NASSAU COUNTY INVITATION TO BID  
 NC21-014-ITB - CR-121, S. 14TH ST., CHESTER RD., SADLER RD., & AMELIA CONCOURSE

SECTION 00 63 63  
 CHANGE ORDER REQUEST FORM

No. 1

**Citrona Drive Sidewalk Improvements LAP, G2717, FIN 441241-1-58-01, Change Order No.1 – CR-L overrun of quantities to match existing special emphasis crosswalk**

Attachment D

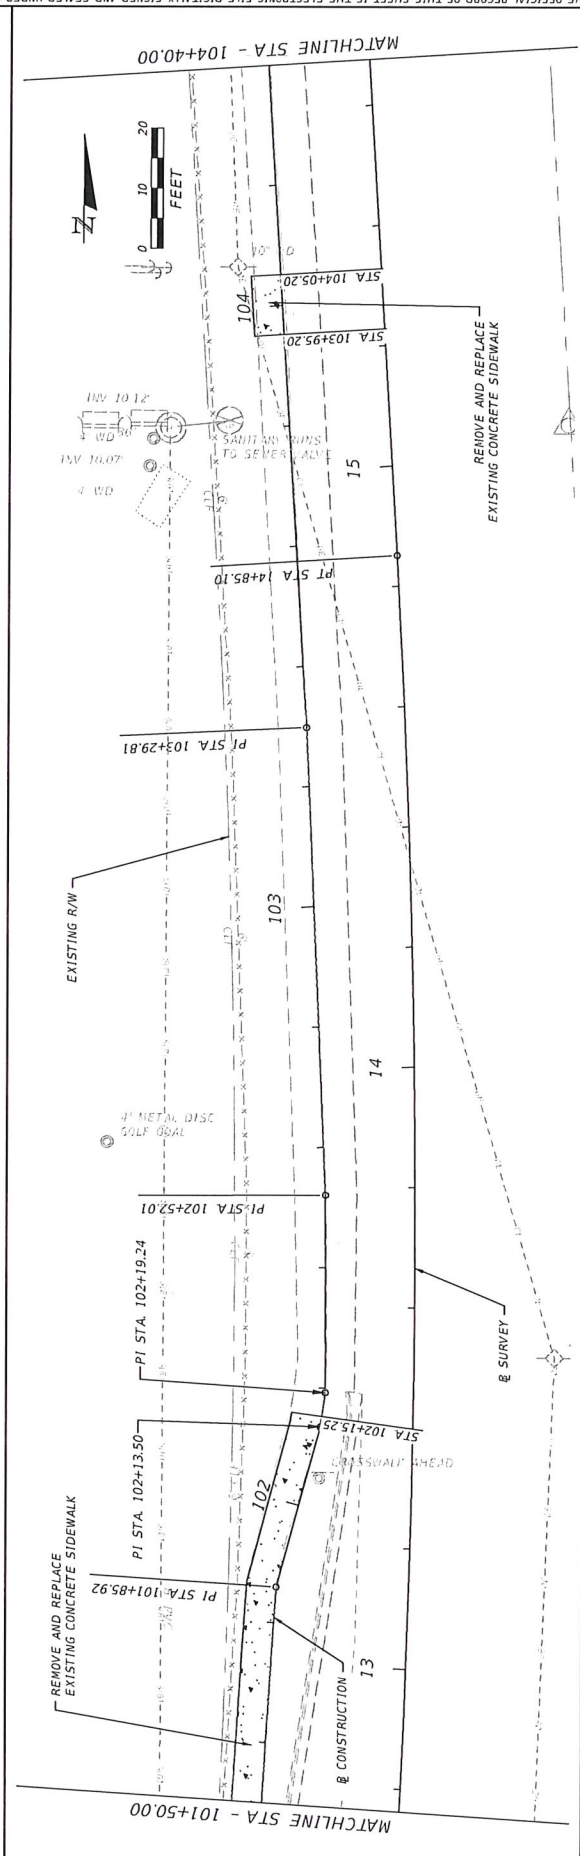
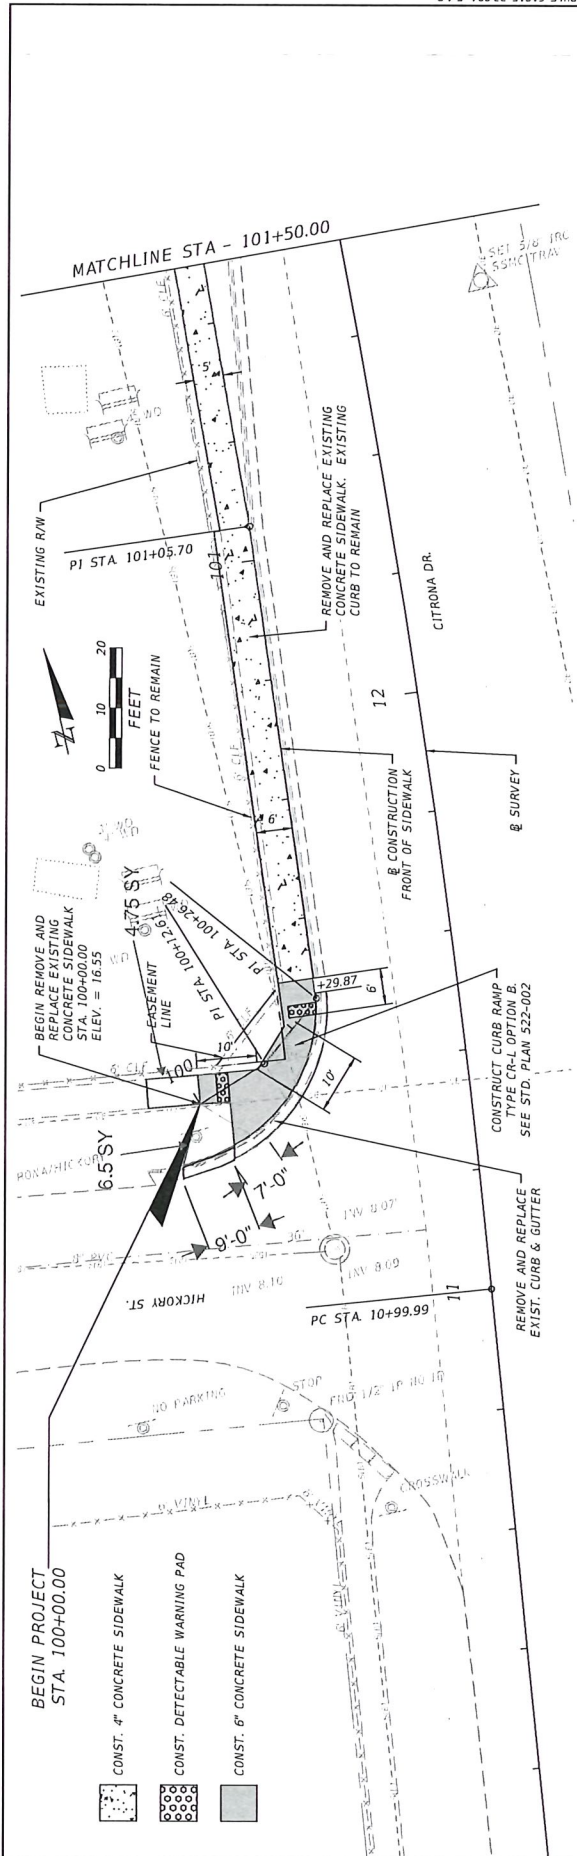
Arne, please see the attached drawing depicting additional work done at the Hickory Street corner.

- Additional 6" SW – 12 SY
- Additional Concrete Removal: 8 SY
- Additional F Curb – 16 LF

Attachment C

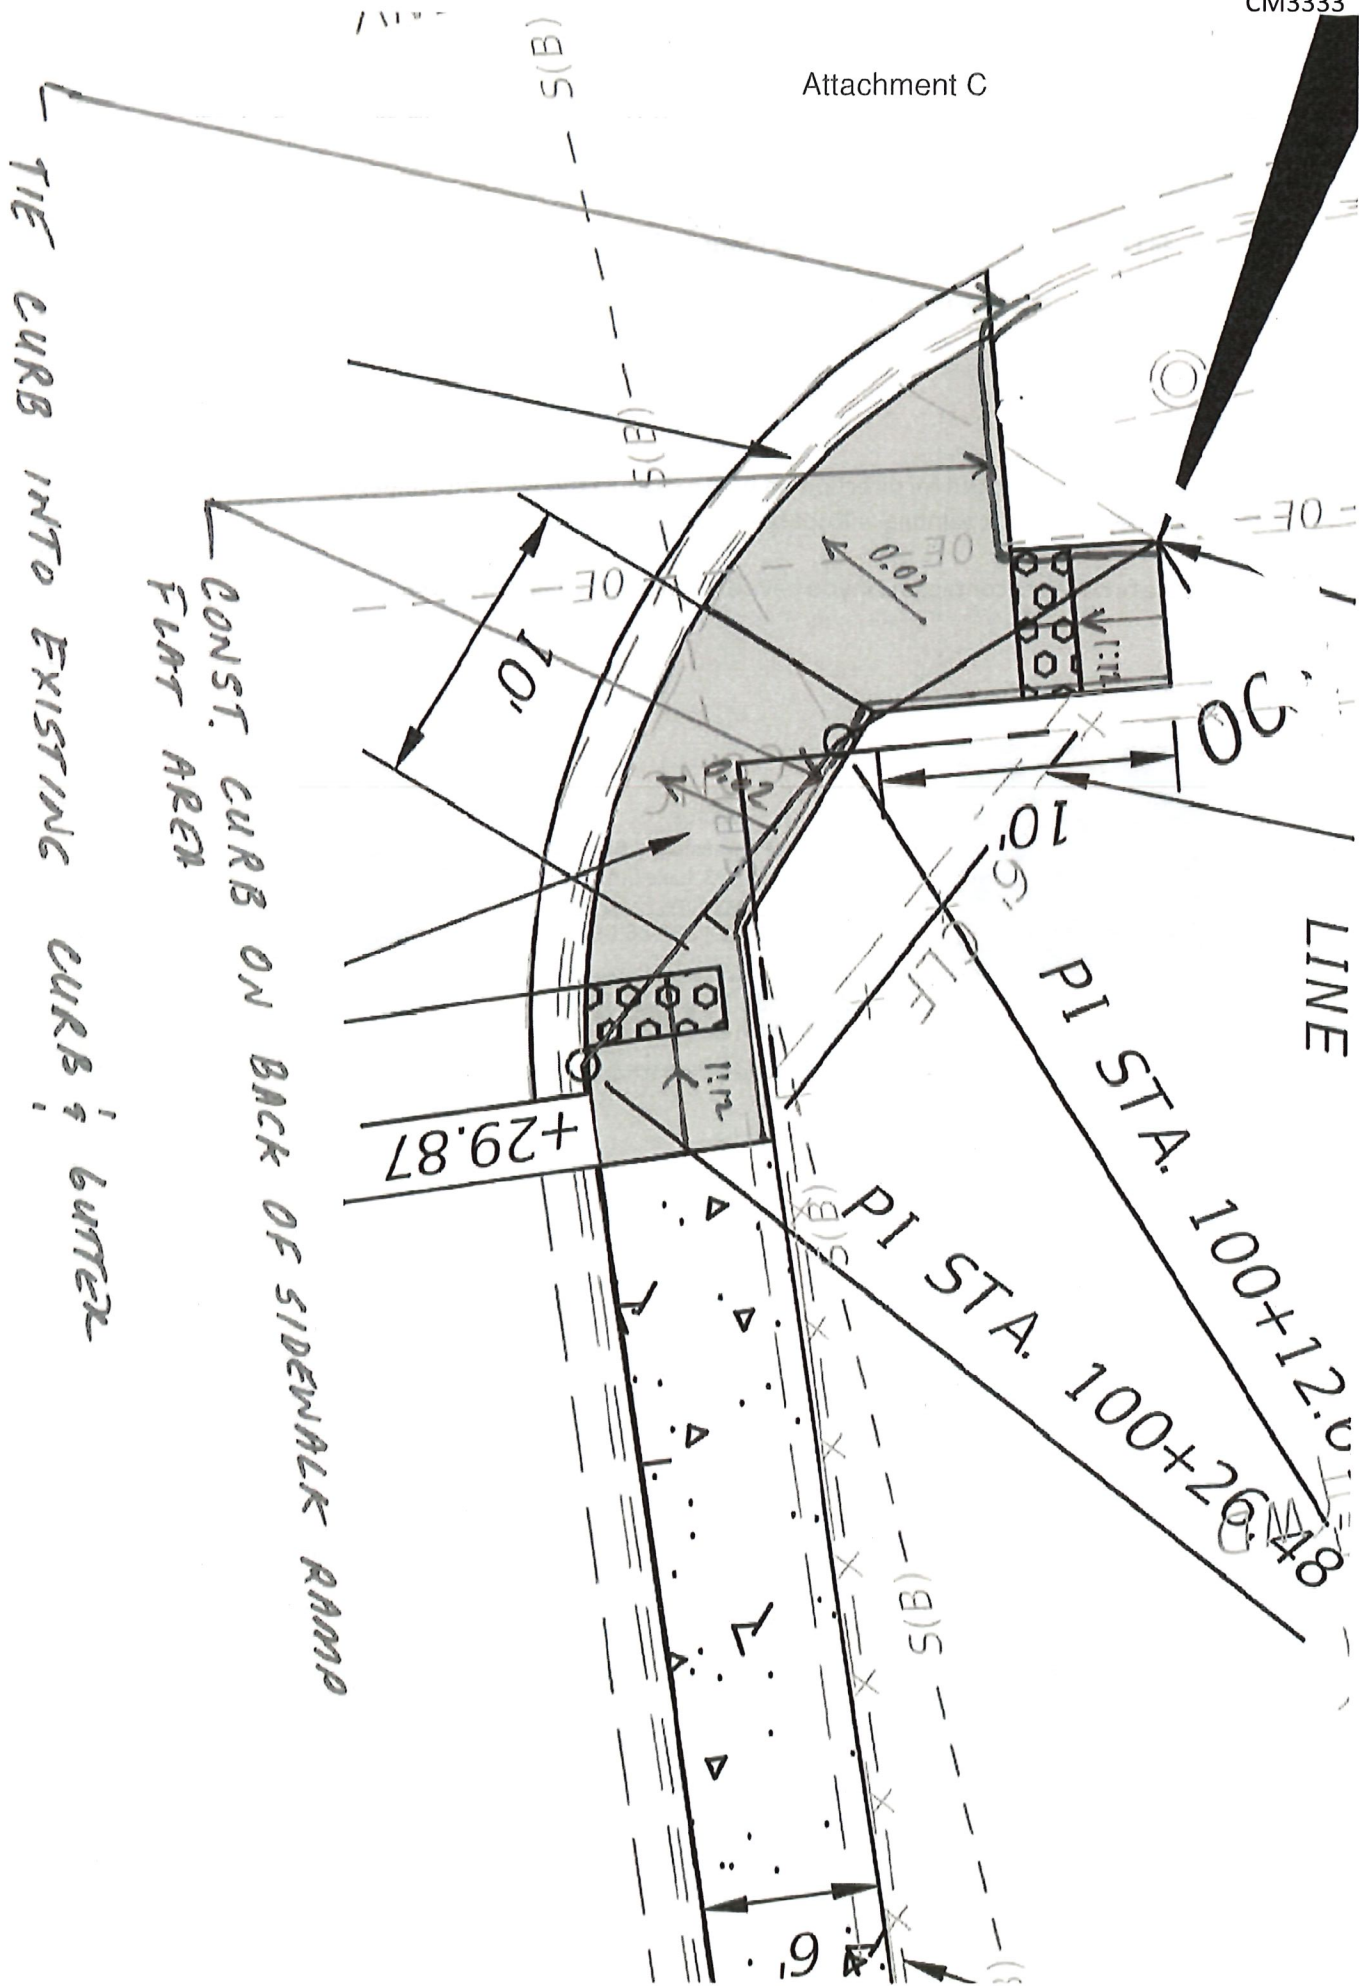
Please see the attached for direction on how to handle the drop curb situation. The existing special emphasis cross-walk painting will not need to be relocated.

*"In order to preserve the existing crosswalk, the County requests that you remove a portion of transition curb previously placed, and extend the curb and new sidewalk as shown in the attached."*

JAMES H. PITMAN, JR. P.E. LICENSE NUMBER 42035 N.E.P.S. P.O. BOX 3823 LAKE CITY, FLORIDA 32056 CERTIFICATE OF AUTHORIZATION 29011		CITRONA DRIVE SIDEWALK ROAD NO. CITRONA DR COUNTY MASSAUS COUNTY FINANCIAL PROJECT ID 44124J-1		SHEET NO. 9
--	--	---	--	-------------

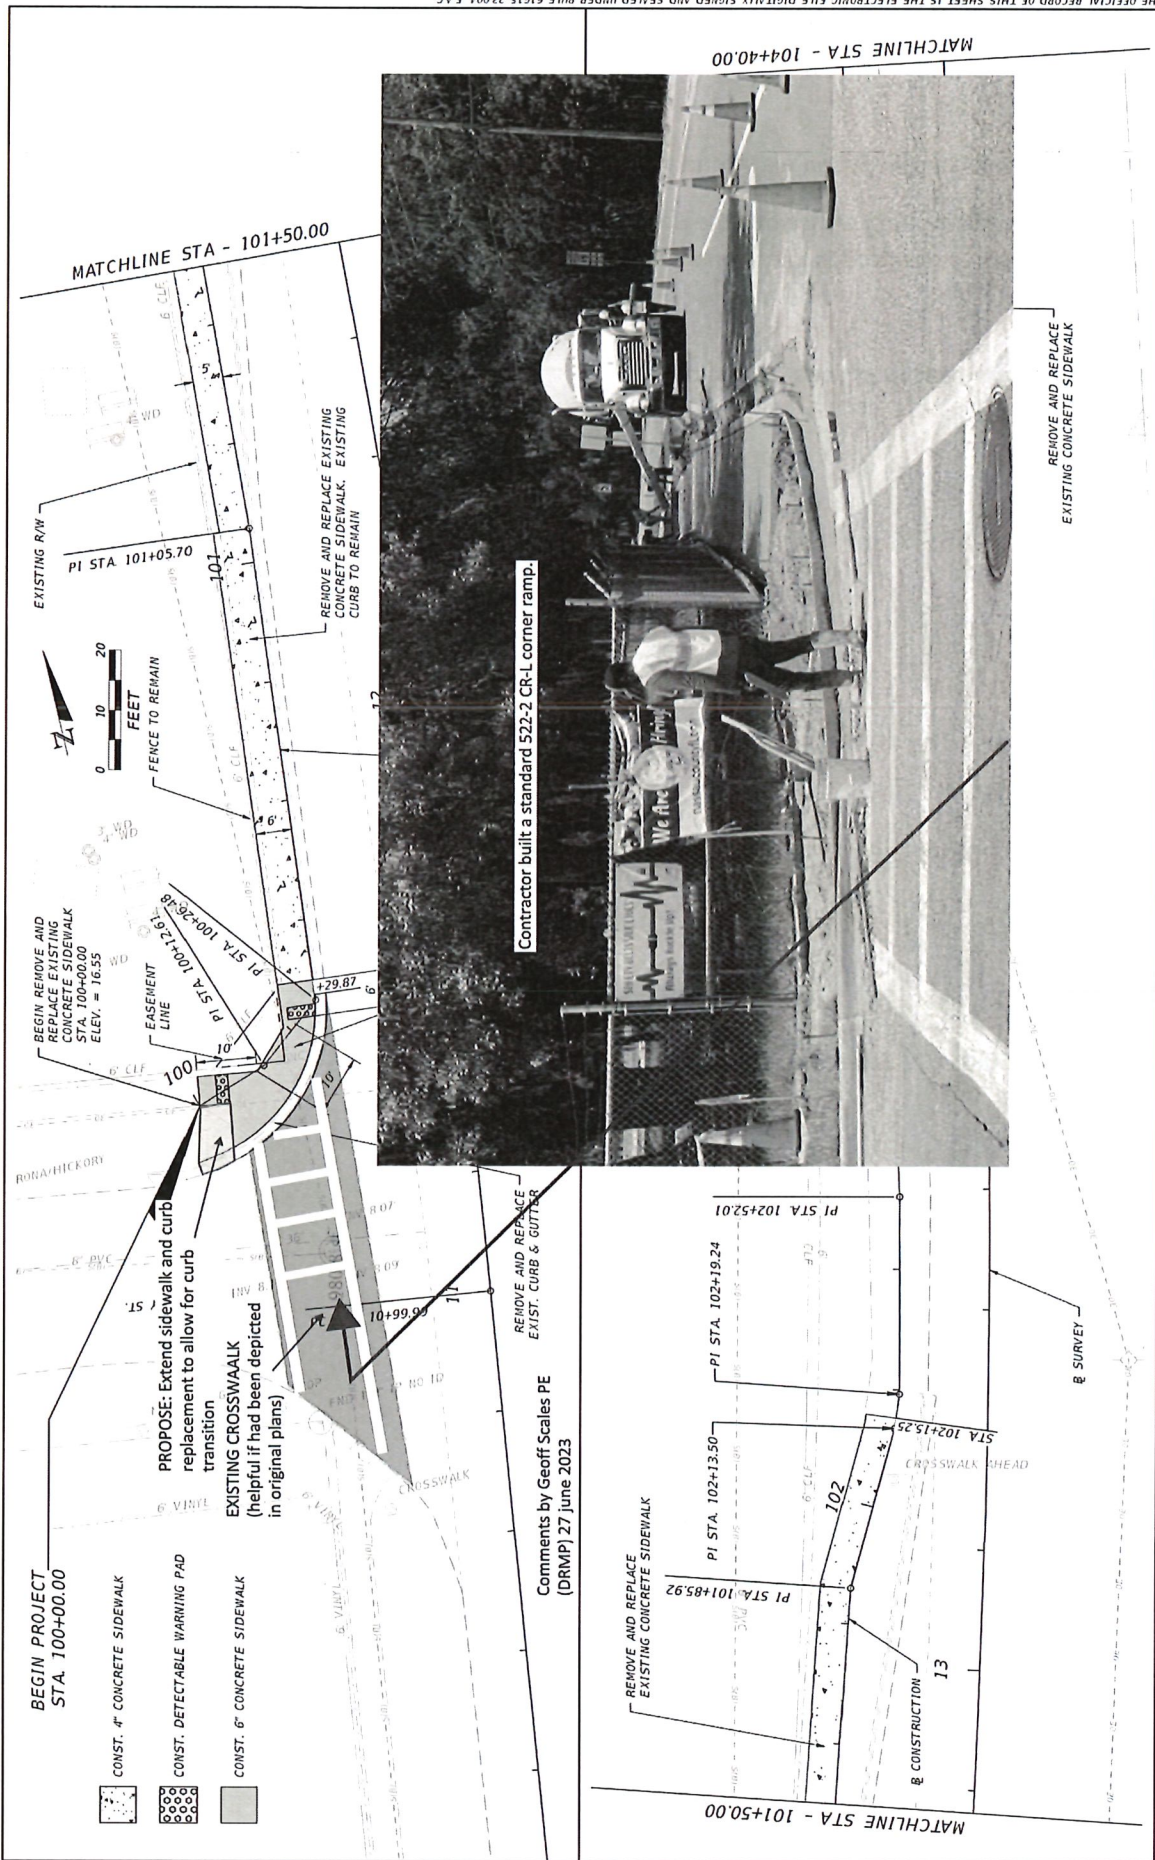
Per our phone conversation earlier this afternoon, I reviewed the plans, sheet 9, and the FDOT Standard Plans, Index 522-002, with the field inspector. The Contractor, CGC, built (the curb section of) a CR-L Ramp, option B, in conformance with 522-002 as modified by the plans, but there was insufficient room for the curb transition-to-drop section that will align with the existing cross walk.

If we are to preserve the cross walk, a short section of curb that was placed yesterday on the N.W. corner of Citrona Dr. and Hickory St. will need to be removed, along with a small additional piece of existing curb. See below and attached. This allows for the drop curb transition to be moved further toward Hickory St., and will slightly increase the curb and sidewalk pay quantities. In addition, the contractor will likely look for some compensation for the piece of new transition poured and subsequently removed.

Attachment A

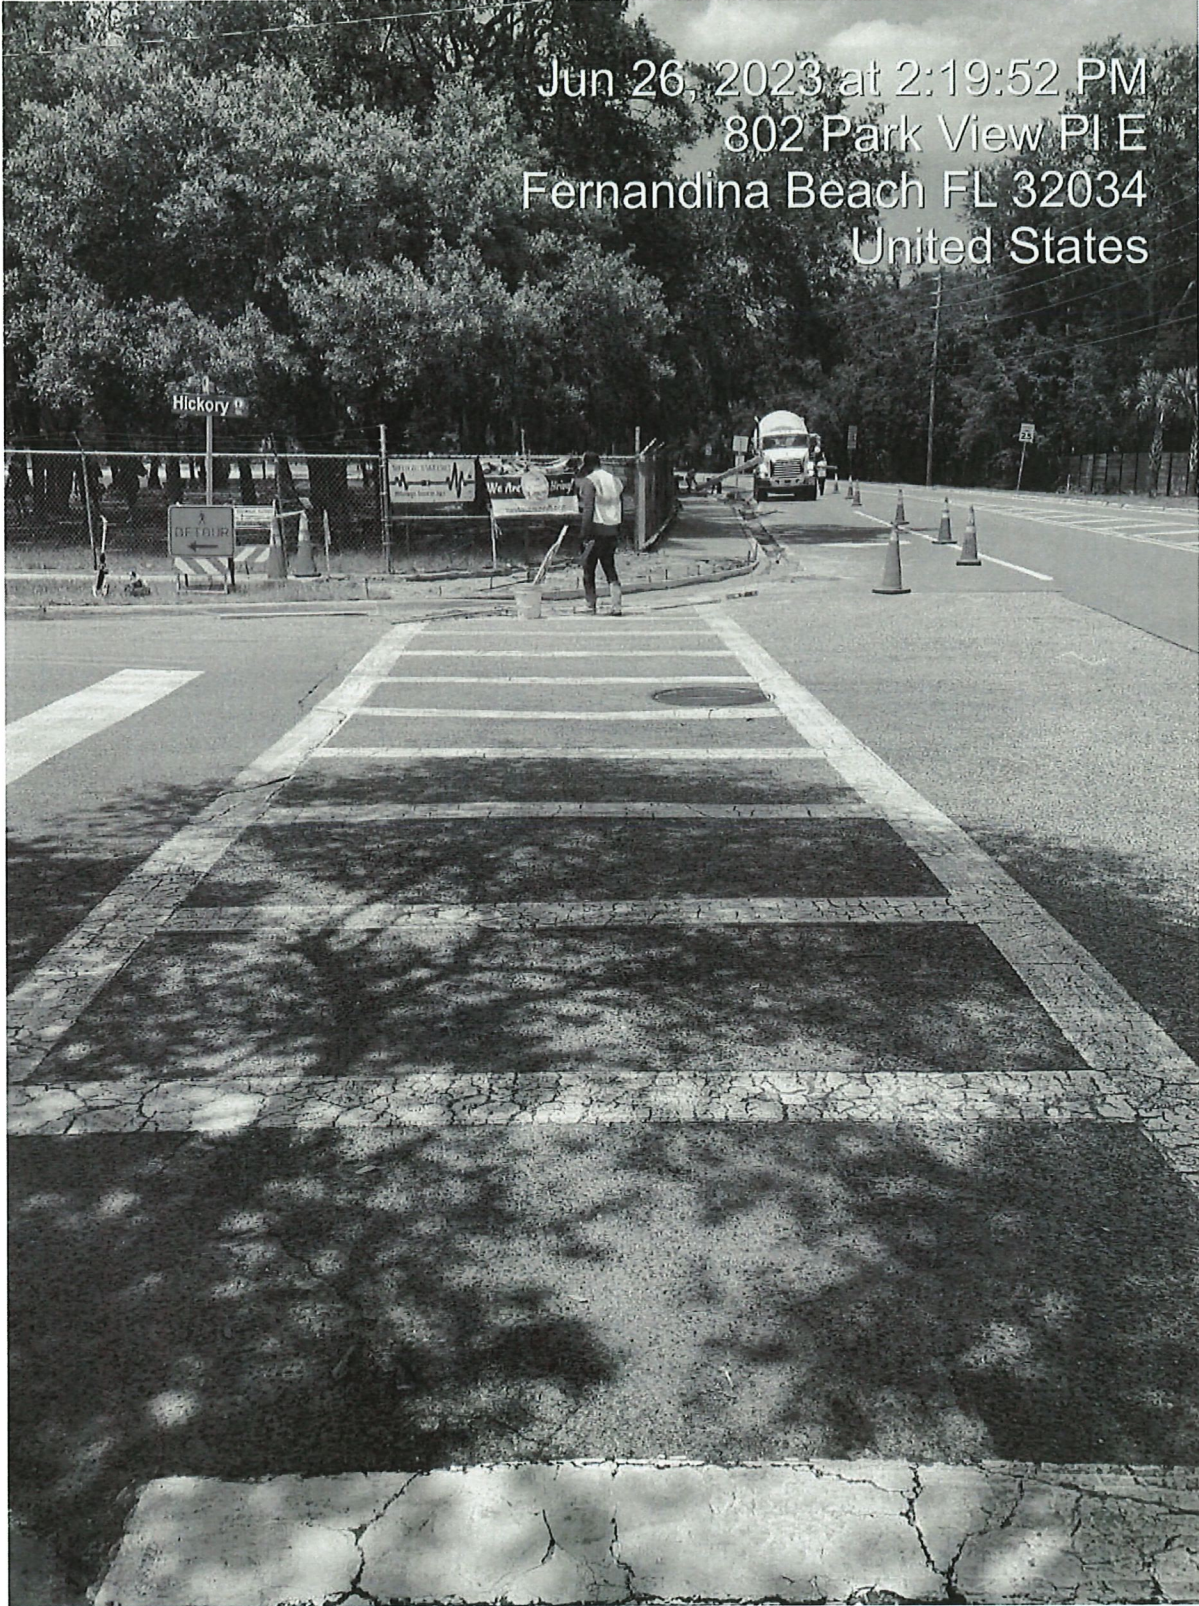
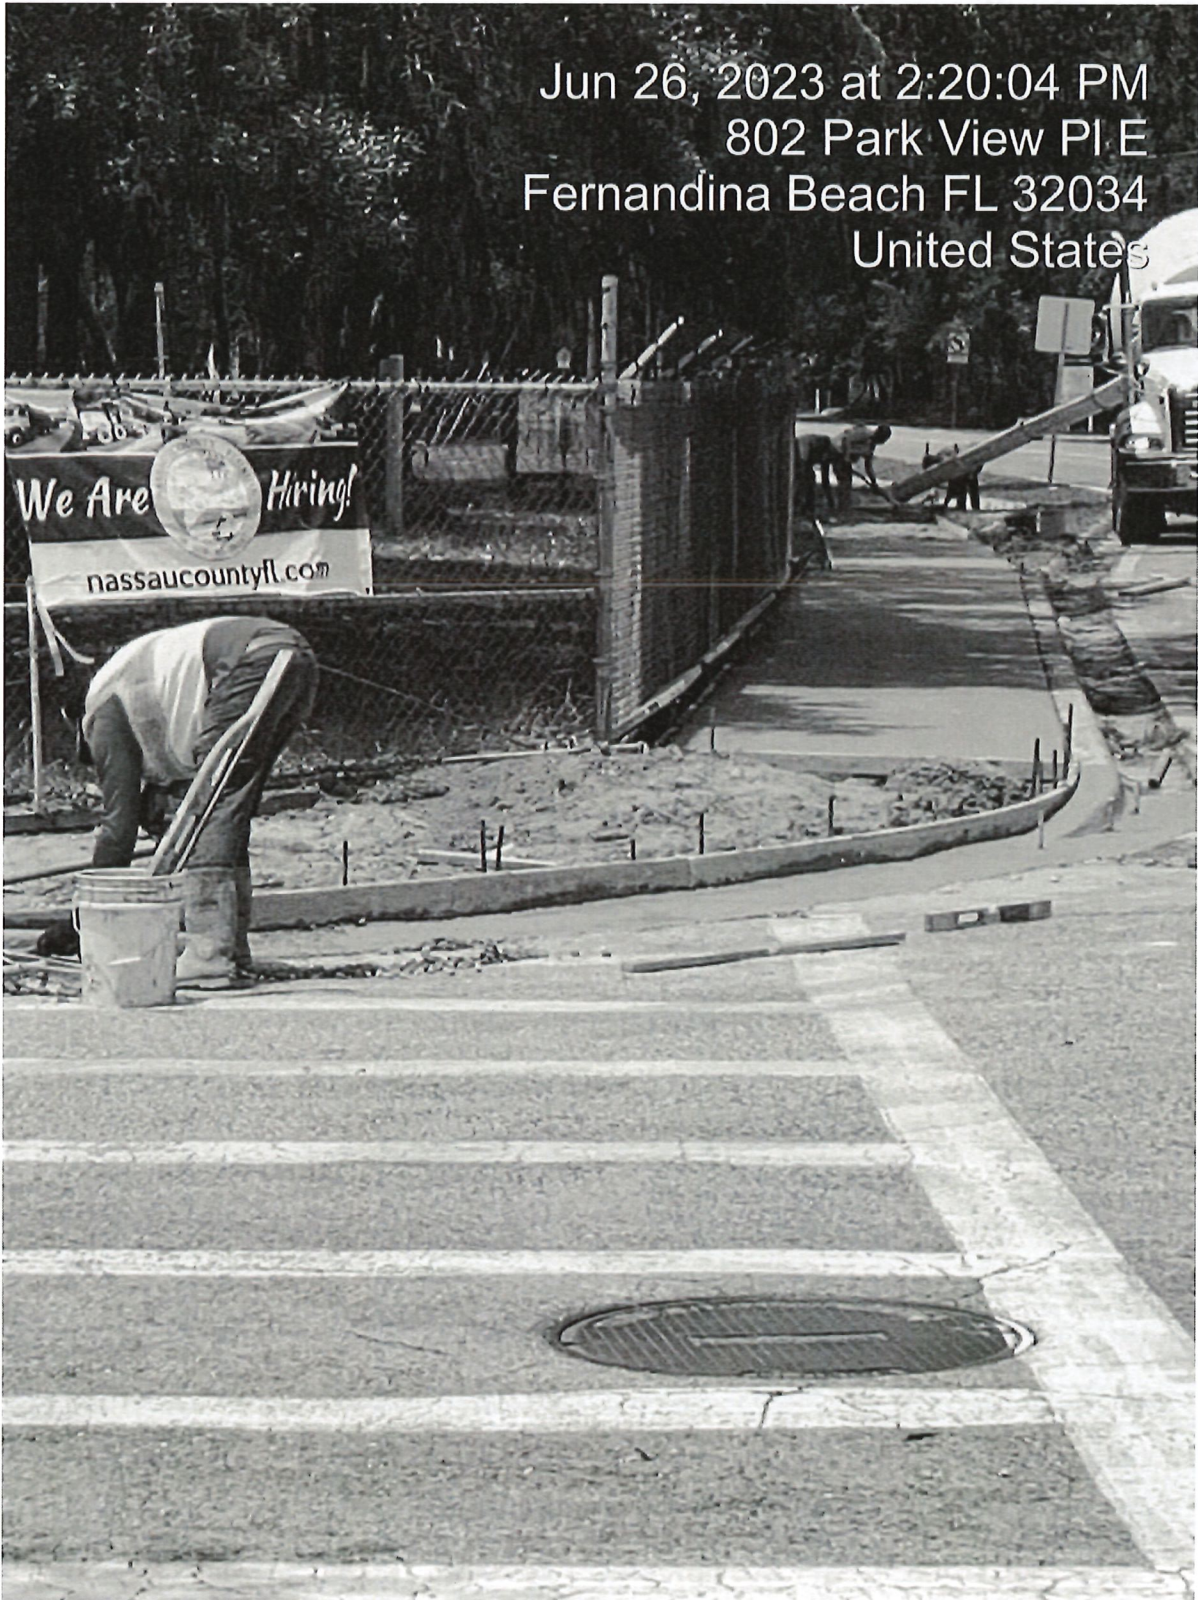
Arne you need to get with the EOR the existing cross walk does not line up with new ADA Ramp.
